Model: Martini-C1		Date: 17-Oct-02	No.: MB064001
Modified Article: Parts Catalog Correction		Prepared by: K. Miura	
From: Technical Services sec. Service Planning Dept.			
Reason for Modification:	☒ Parts catalog correction ☐ To facilitate assembly ☐ Part standardization	☐ Vendor change ☐ To improve reliability ☐ Other	☐ To meet standards ()

Please correct your Parts Catalogs as follows:

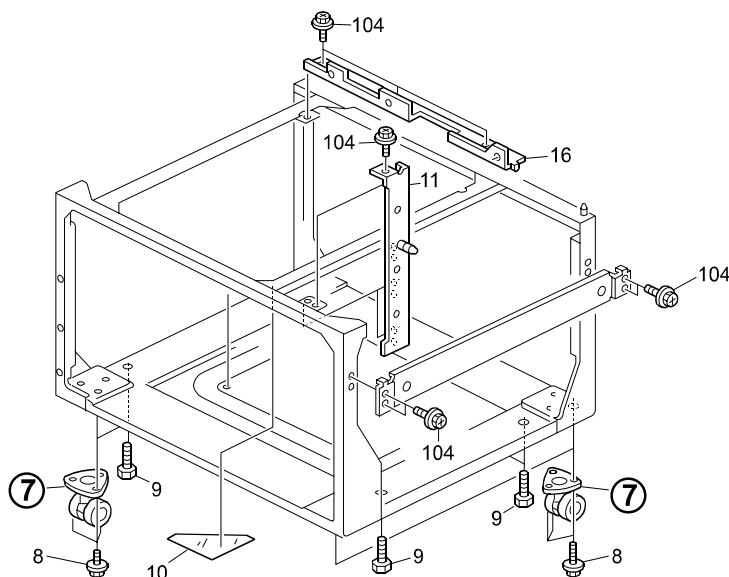
The following part has been changed due to a vendor change:

Old part number	New part number	Description	Q'ty	Int	Page	Index	Note
AH012016		Caster - G60	4		145	7	
	AH012015	Caster - 1470N	4	O/O	145	7

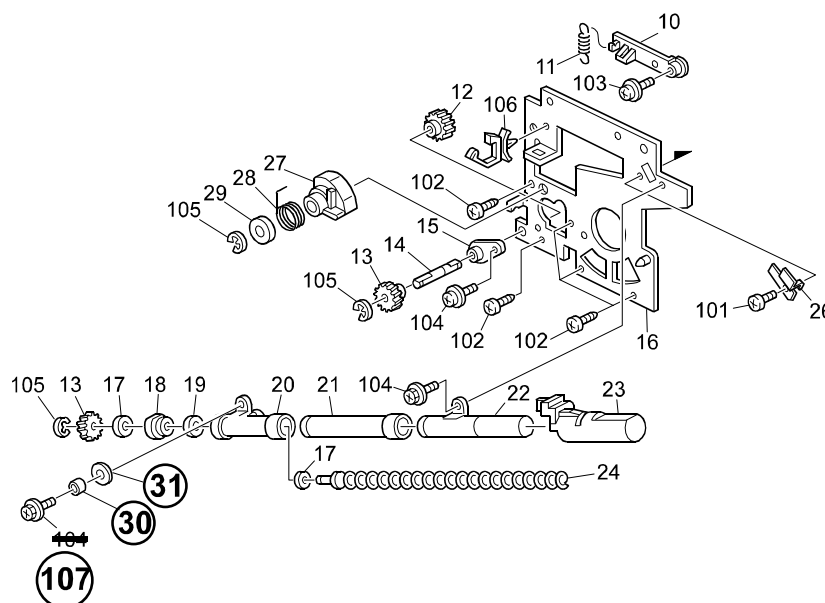
The following part has been added to ensure the Brush Roller Gear does not break:

Before installing the Cushion -T1 (A3764131), insert the Sleeve (AA130042) into the hole in the Cushion - T1.

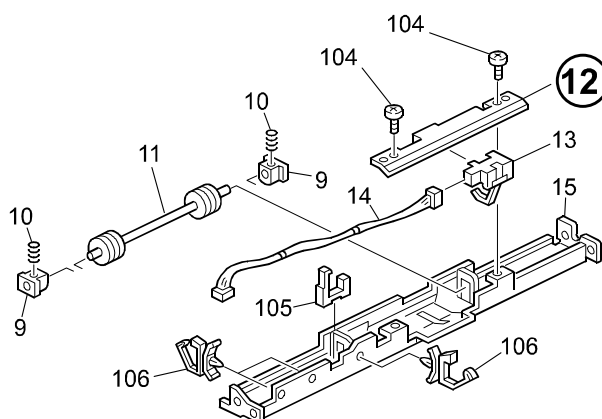
The following part has been modified to ensure that the Driven Exit Roller stays properly secured in place.

Old part number	New part number	Description	Q'ty	Int	Page	Index	Note
B0654355	B0654358	Paper Feed Sensor Bracket	1	X/O	103	12

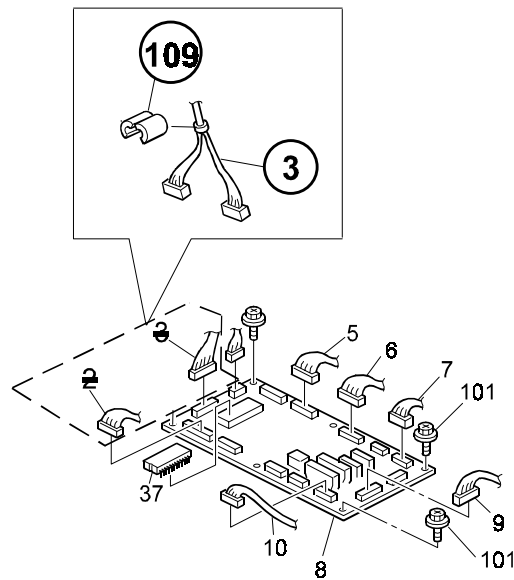
The following have been changed to provide an even greater margin in conforming to EMI Standards.

Old part number	New part number	Description	Q'ty	Int	Page	Index	Note
B4775641		Paper Size Sensor Harness	1		39	2	
B4775661	B4775601	Registration Sensor Harness	1	X/O	39	3	
	16070622	Ferrite Core TFC16816	1		39	109

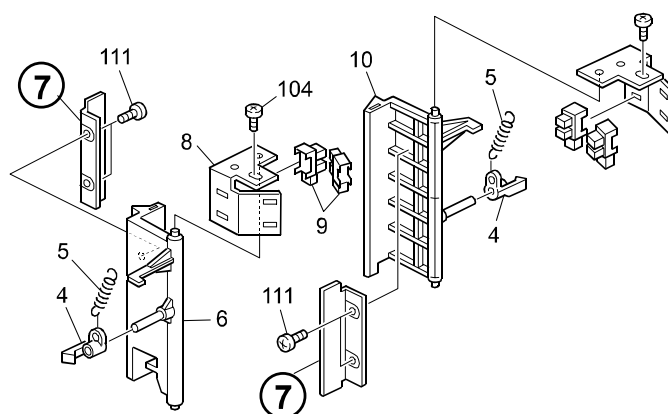
The parts below have been modified to ensure that the shaft for the front end fence of the tandem tray does not break.

Old part number	New part number	Description	Q'ty	Int	Page	Index	Note
A2936712	B0656712	End Fence Guide	2	X/O	57	7

Note: Both the old and new End Fence Guides above can be used with the Rear End Fence (O/O).

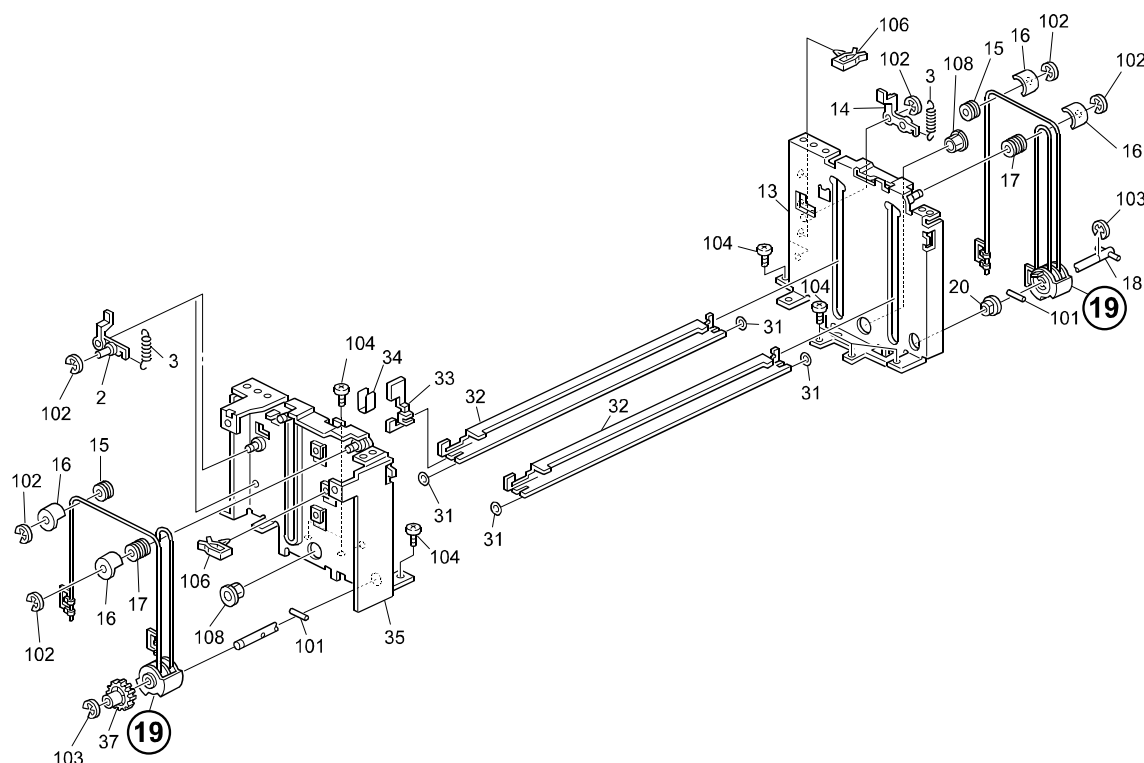
Old part number	New part number	Description	Q'ty	Int	Page	Index	Note
A2486684	A2936684	Pulley Drive Wire Ass'y	2	X/X	57	19

Note: When replacing, it is necessary to replace **both** Pulley Drive Assemblies together as a set.

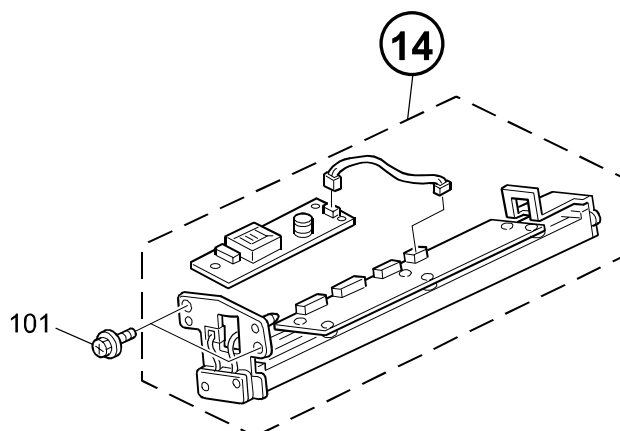
The following part has been changed due to a vendor change.

Old part number	New part number	Description	Q'ty	Int	Page	Index	Note
B4775830	B4775840	Contact Image Sensor	1	O/O	33	14

<Page 97>

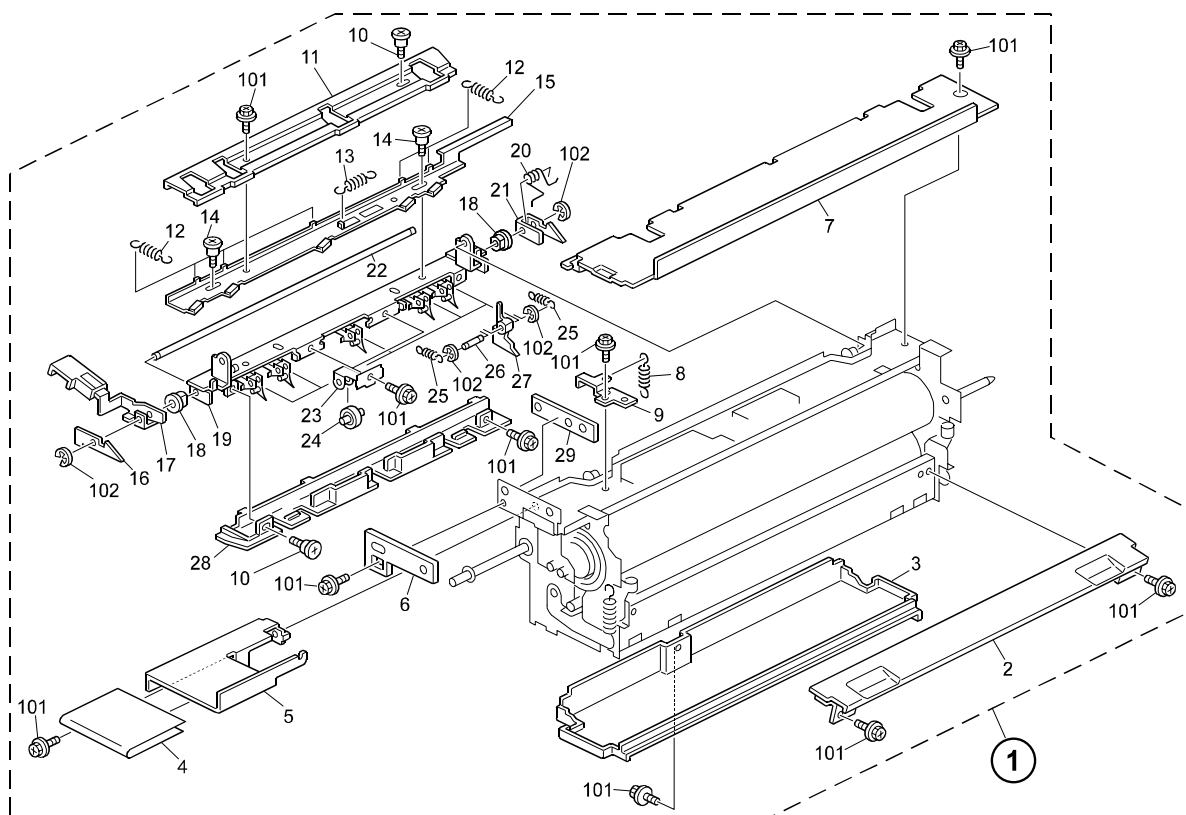
The Hot Roller has been modified to ensure that it reaches its lifetime of 500k.

Old part number	New part number	Description	Q'ty	Int	Page	Index	Note
B0654018	B0654016	Fusing Unit - 120V	1	X/O	97	1	
B0654028	B0654029	Fusing Unit - 230V	1	X/O	97	1	
B0654020	B0654021	Fusing Unit (TWN)	1	X/O	97	1	
AE011075	AE011087	Hot Roller	1	X/O	99	23

39 BOTTLE DRIVE ASS'Y

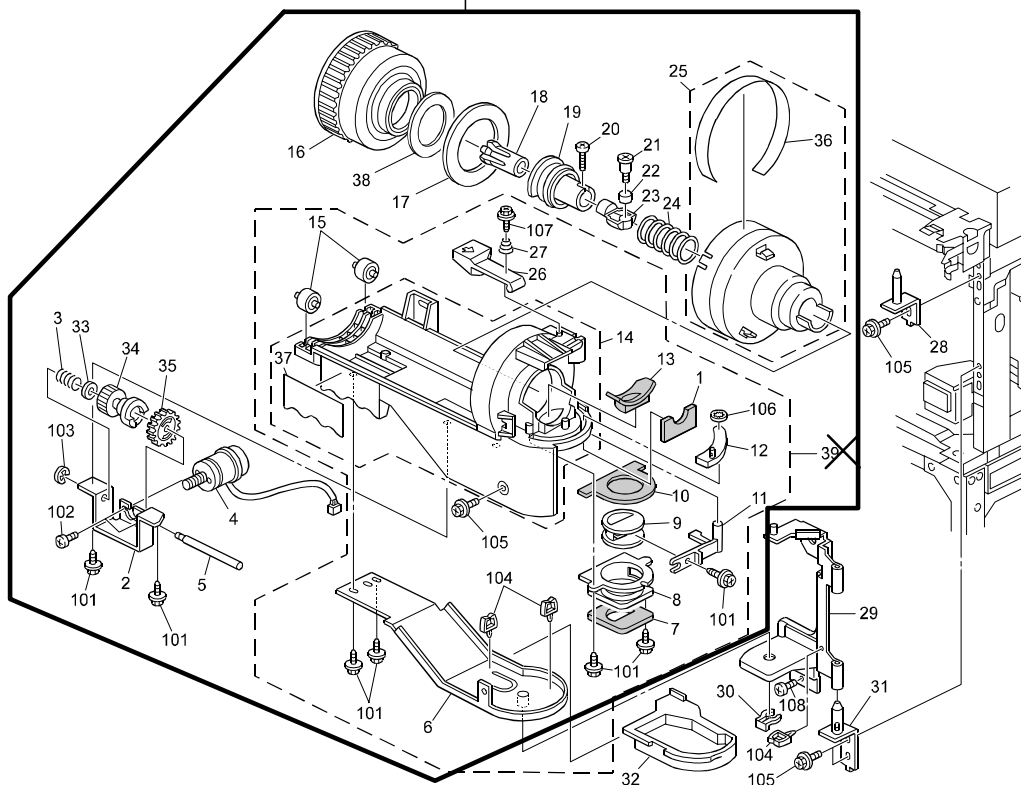
Part Number	Incorrect Description	Correct Description	Int	Page	Index	Note
B0653301	BOTTLE:DRIVE	BOTTLE:DRIVE:ASS'Y	1	74	39

4.DF EXTERIOR

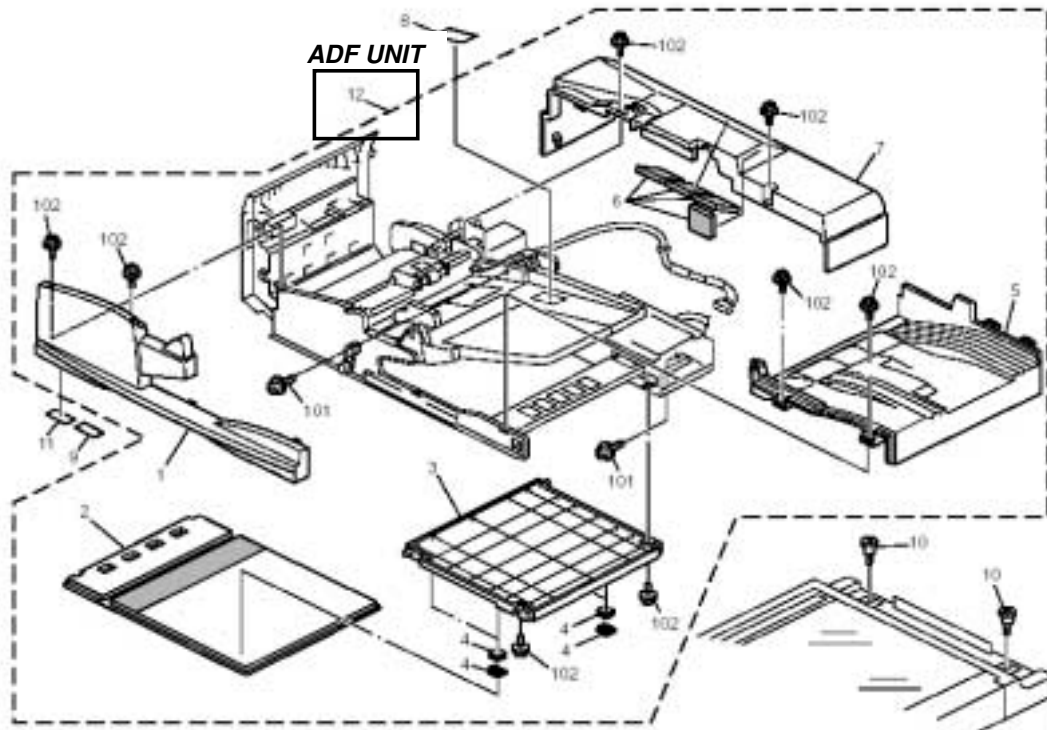
Old part number	New part number	Description	Q'ty	Int	Page	Index	Note
B0657001	B0657002	ADF UNIT	1	O/O	21	12
